C_{Port} and C_{Port-2P} baseline v122

Proposal:

Figure 33–33 — C_{Port} and $C_{Port-2P}$ interpretation model

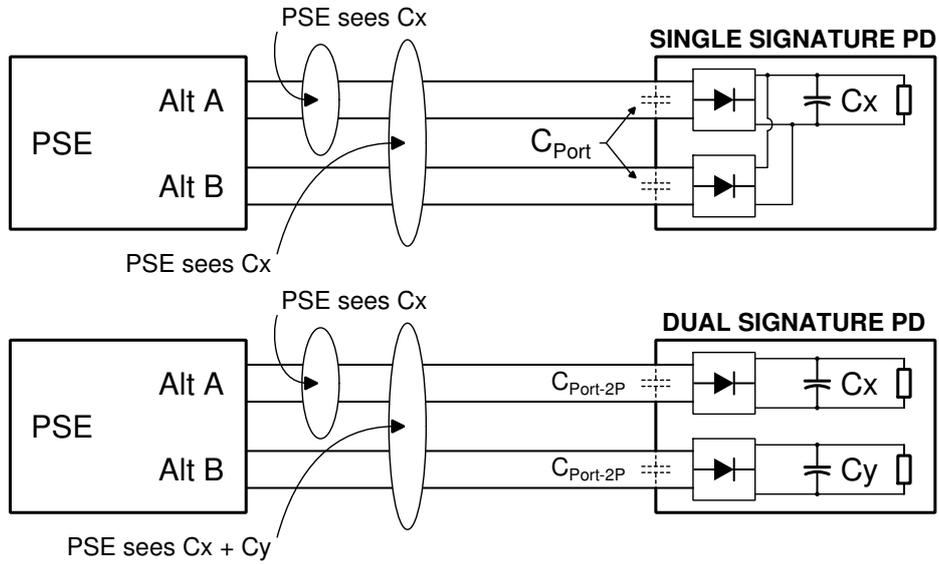
C_{Port} in Table 33–28 is the total PD input capacitance during the POWER_UP and POWER_ON states that a PSE encounters sees as load when operating one or both pairsets, when connected to a single-signature PD. C_{Port-2P} in Table 33–28 is the PD input capacitance during the POWER_UP and POWER_ON states that a PSE sees as load on each pairset independently, when connected to a dual-signature PD. ~~When a PSE is connected to a dual-signature PD, C_{Port} value requirements are specified in 33.3.7.6.~~ See Figure 33–33 for a simplified PSE-PD C_{Port} and C_{Port-2P} interpretation model.

Replace Figure 33–33 as follows:
